### QUESTIONS ON THE ACR RESPONSES

These questions were developed subsequent to the review of several submittals by the Price River Coal Company in response to an Apparent Completeness Review completed by OSM and DOGM on December 7, 1982.

Subject: Price River Coal Company, Price River Complex,  
Carbon County, Utah, Mining and Reclamation Plan

Subject: Price River Coal Company, Price River Complex  
Carbon County, Utah, Mining and Reclamation Plan

Chart 2-53: HEADWATER DEPTH FOR C.M.P. CULVERTS WITH INLET CONTROL

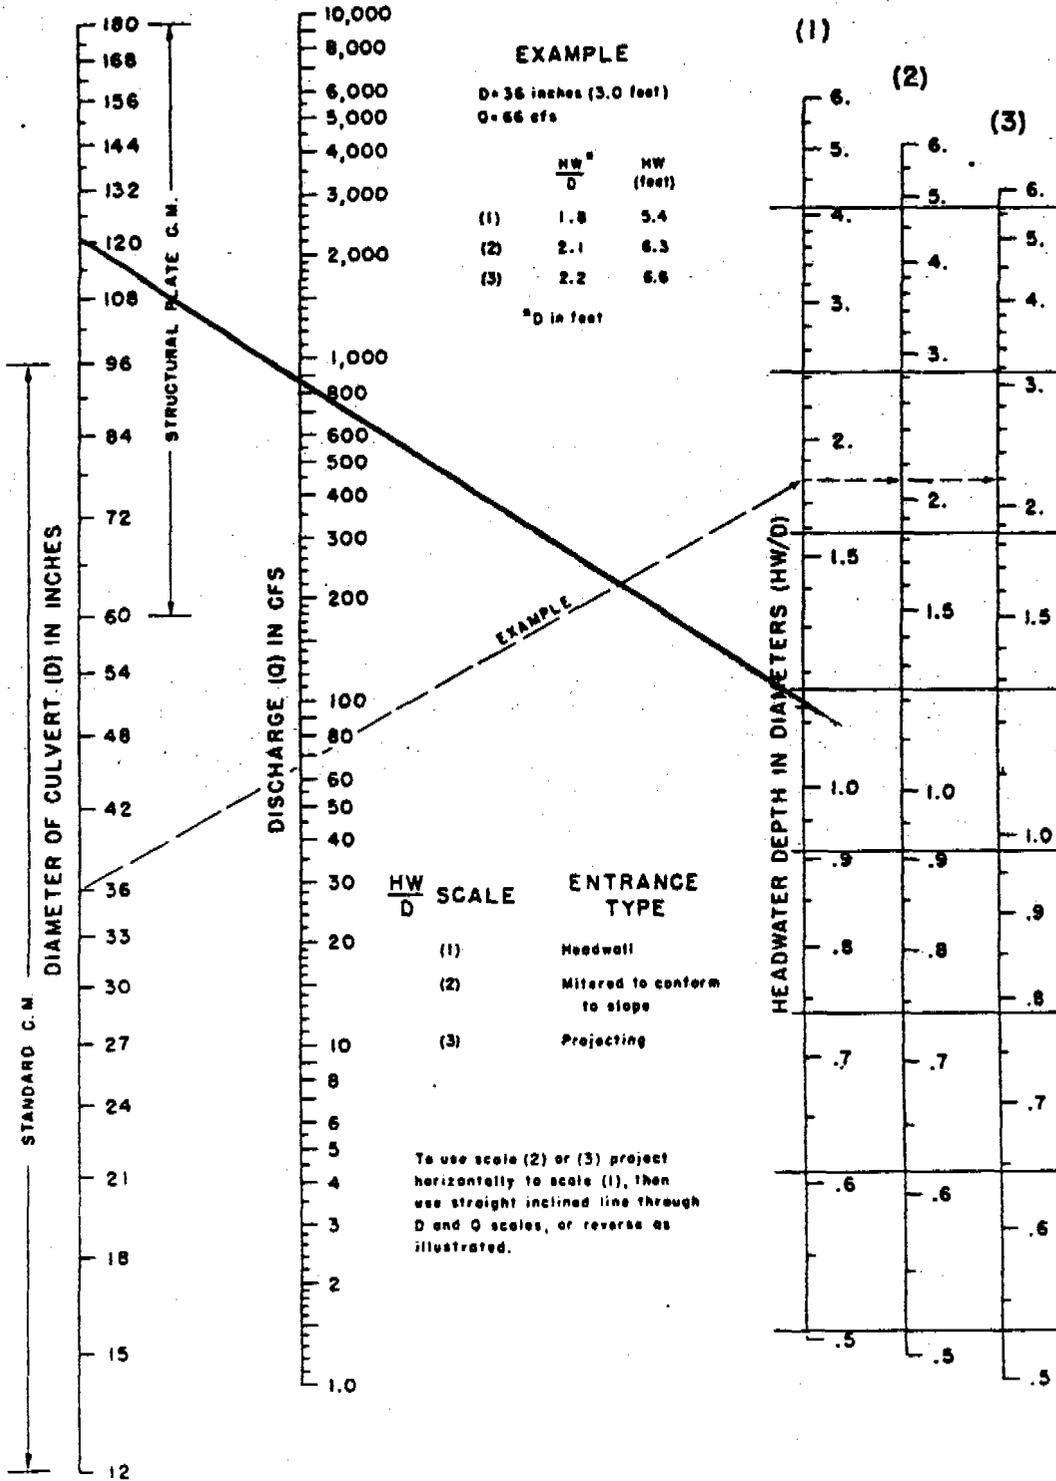
The Division has completed its review of the proposed stream channel culvert modification submitted by Price River Coal Company on July 12, 1983, and has determined that the 10-foot diameter smooth steel pipe is adequate to handle the probable flood event for the projected life of the access area. I apologize for not getting this reviewed sooner, but the staff had a difficult time finding a nomograph for smooth steel pipe and also locating your borrow site.

DESIGN WORKSHEET FOR TRAPEZOIDAL SHAPED CHANNEL

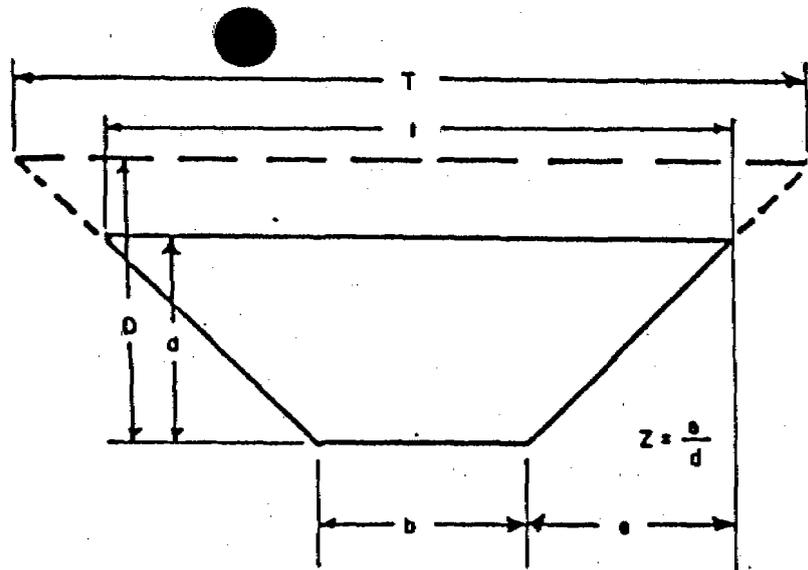
- (5) The applicant shall redesign reclaimed ditch section RC-5 to provide sufficient flow capacity to pass the peak flow from a 10-year, 24-hour storm event.
